Rezoning Transportation Analysis

Petition Number: 2018-047

Date	Description
04-23-2018	First Review
05-21-2018	Second Review

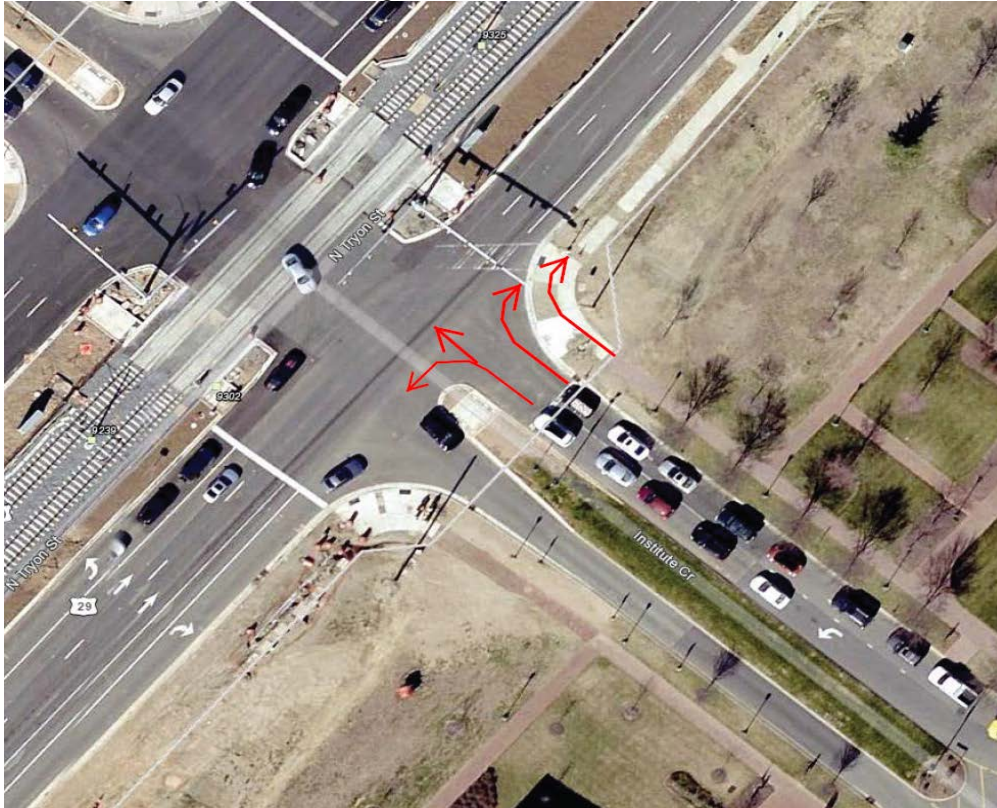
- ~~5. The petitioner should revise the site plan and conditional note(s) to add a third lane travel lane to the Institute Circle westbound approach (i.e. a single left/thru lane and dual right turn lanes). The dual rights should be channelized, and the pork-chop island should be large enough to serve as a pedestrian refuge with pedestrian signals and pushbuttons to accommodate the pedestrian traffic (see conceptual transportation improvements below).~~

CDOT has recently remarked and signed the westbound Institute Circle approach to provide a left turn/thru lane and a dedicated right turn lane to help mitigate right turn queuing issues which sometimes stack into the existing roundabout at Robert D. Snyder Road.
